Village of Arlington Heights
Conceptual Plan Review Committee
Community Room, 3rd Floor
Arlington Heights Village Hall
33 S. Arlington Heights Road
Arlington Heights, IL 60005
July 24, 2019
6:00 PM

Item: Northwest Crossings - 1501 W. Shure Dr. - T1671

VILLAGE OF ARLINGTON HEIGHTS **STAFF DEVELOPMENT** **COMMITTEE REPORT**

Temp File Number: T1671
Project Title: Northwest Crossings PUD
 Amendment
Address: 1455, 1421, and 1501 W. Shure Dr.
PIN: 03-07-100-015, -021, -023, and -024

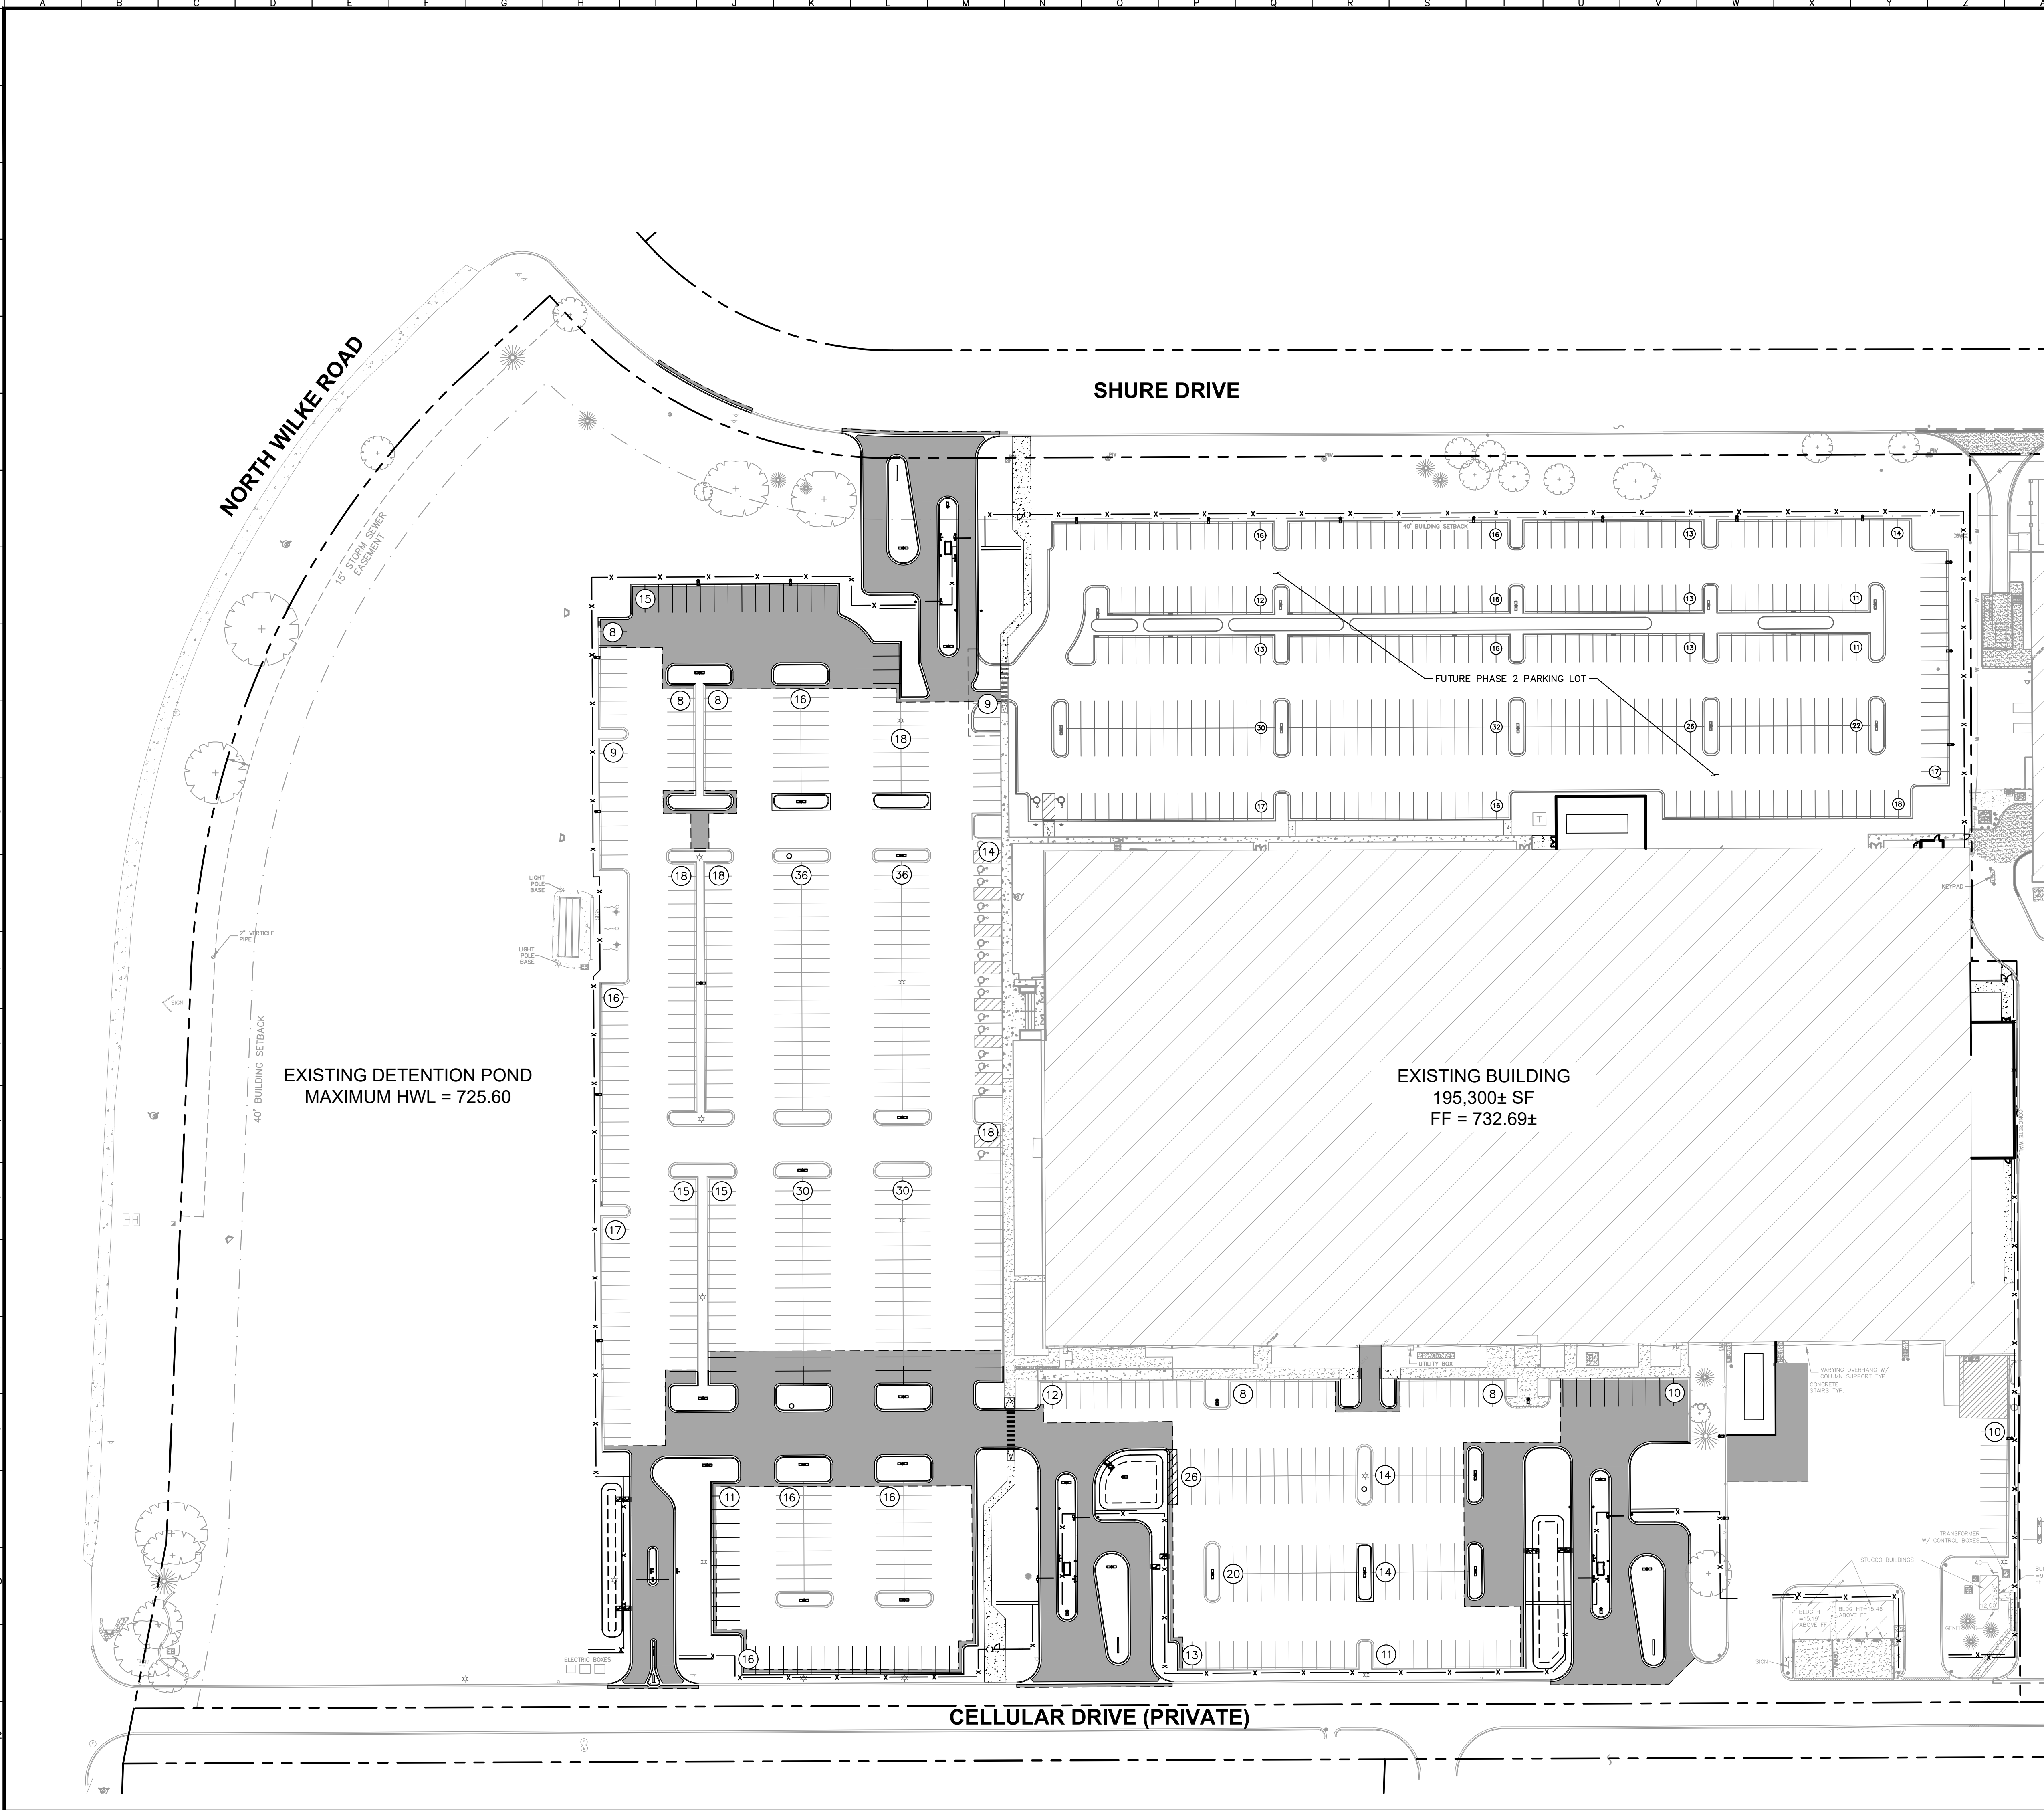
Per Chapter 28, Section 6.12-1(2)a, the petitioner is required to provide a traffic and parking study by a certified traffic engineer that assesses access (location, design, and Level of Service), on-site circulation, trip generation and distribution, parking, and impacts to public streets. Relative to this requirements, the petitioner has requested the following variation:

- **A Variation from Chapter 28, Section 6.12-1, to waive the requirement for a traffic and parking study prepared by a qualified professional engineer.**

The petitioner shall be required to provide a written response to each of the four hardship criteria to justify said variation. Staff is supportive of this variation for several reasons; 1) each phase of development will exceed the required number of parking spaces, 2) approximately 223,000 square feet of floor area has been demolished within the PUD over the last 5 years, and 3) a previous condition of approval requires that should parking within the PUD become a problem at any point in the future, the petitioner must develop a plan to address the problem upon the request of the Village.

As shown in the table above, occupancy of the Phase II portion of the building without the concurrent construction of the Phase II parking would result in a parking deficit on the site. As a condition of approval, staff recommends that build-out and occupancy of the 69,136 square foot Phase II area must occur simultaneous to construction of the Phase II parking area.

- **The variance requested is the minimum variance necessary to allow reasonable use of the property.**
2. Build-out and occupancy of the 69,136 square foot Phase II area must occur simultaneous to construction of the Phase II parking area.

TYPICAL FENCE DETAIL

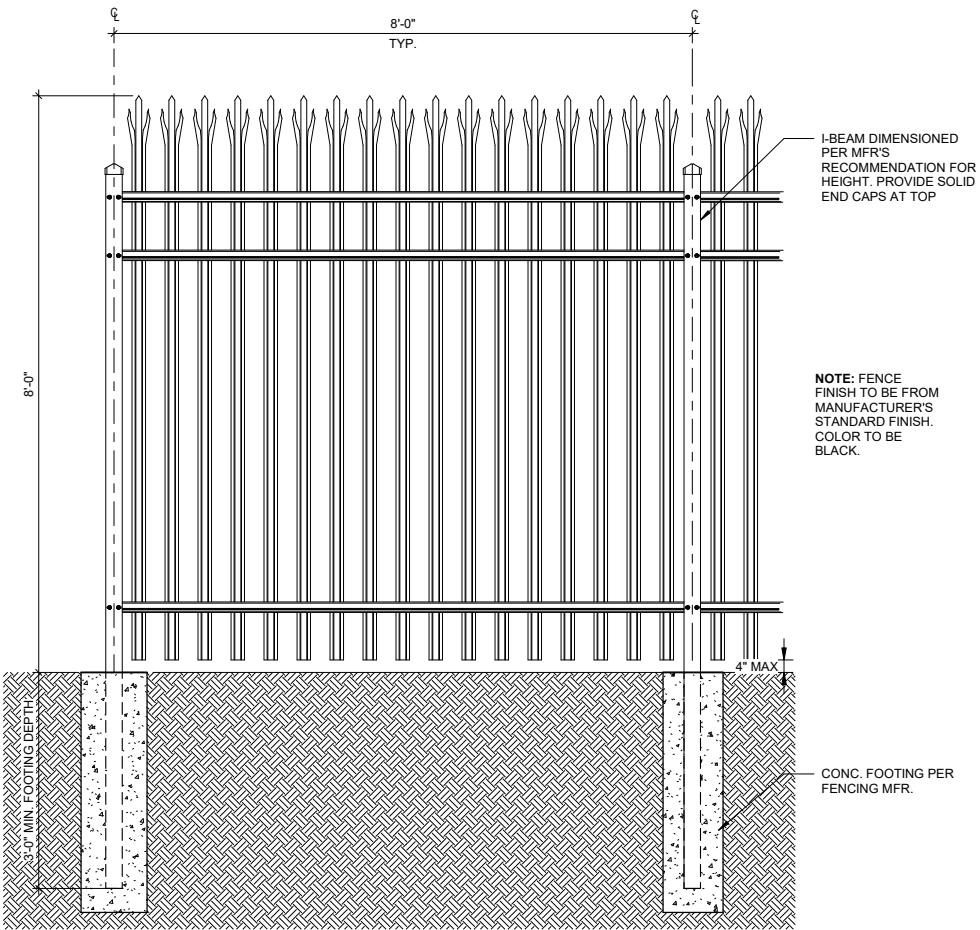
1. Section 6.13-3a, Front Yard, to allow a 8-foot tall open fence with sharp points in a front yard.
2. Section 6.13-3b.2, Corner Lot, to allow an 8-foot tall open fence in a rear yard.
3. Section 6.13-3c.1, Exterior Side Yards, to allow an 8-foot tall open fence in an exterior side yard.
4. Section 6.12-1, to waive the requirement for a traffic and parking study prepared by a qualified professional engineer.
